PUBLIC INTEREST REVIEW FOR GROUND WATER APPLICATIONS

SUBJECT: Application G- 17545 Supersedes review of _____
Date of Review(s)

A. GENERAL INFORMATION: Applicant's Name: Sam McDaniel County: Malheur

Application G-17545, Sam McDaniel

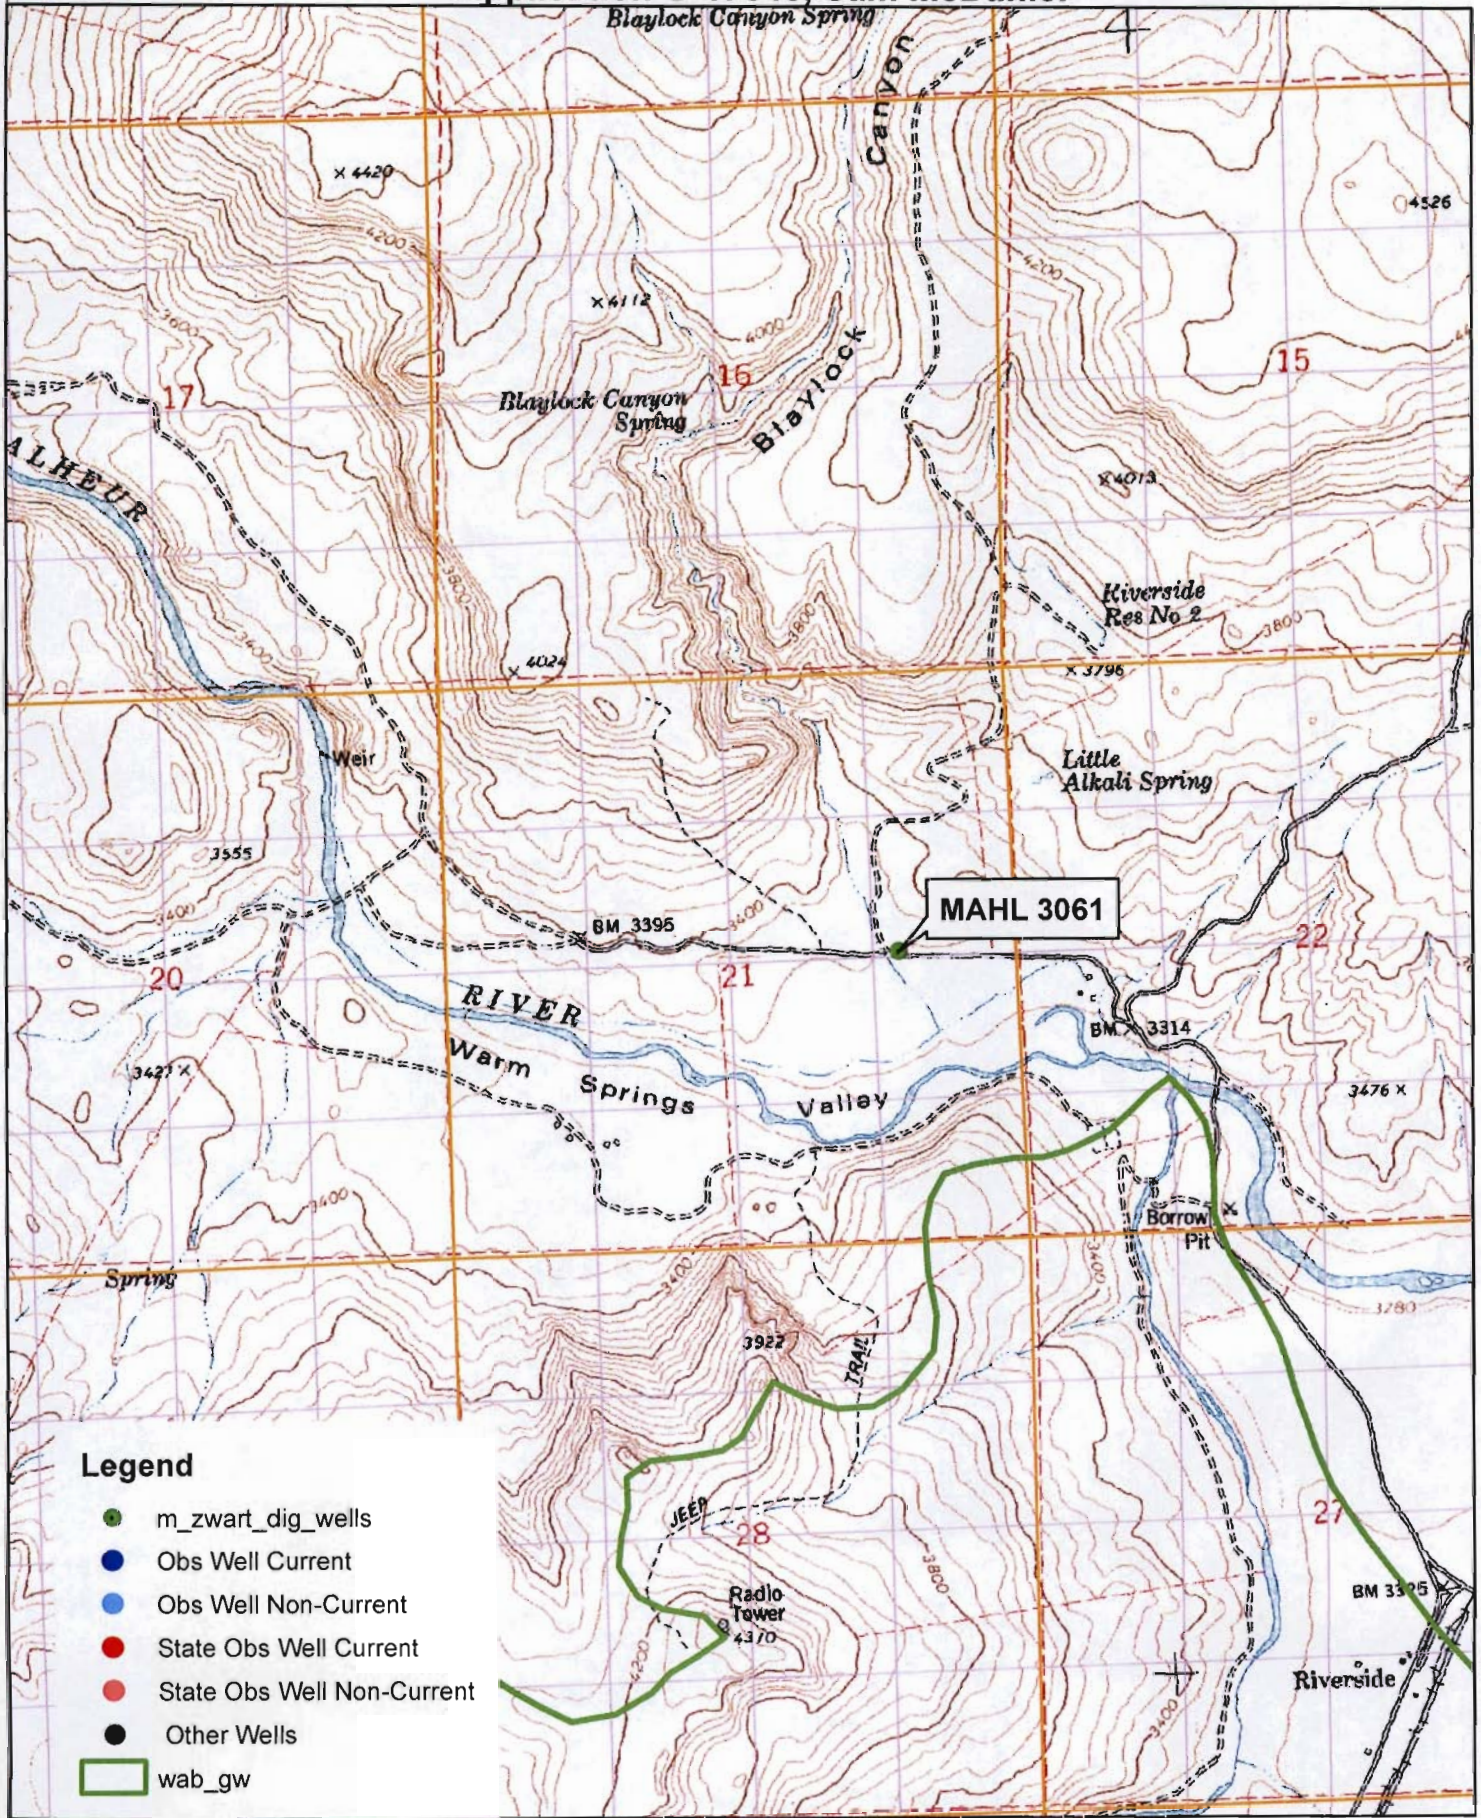
A4. **Comments: Well constructor apparently mislocated the well in Section 27. It is not clear that the subject well is capable of producing the requested quantity of water.**

Basis for aquifer hydraulic connection evaluation: The basalt aquifer may provide some recharge to the overlying alluvium adjacent to the river, so it may be in indirect hydraulic connection with the river.
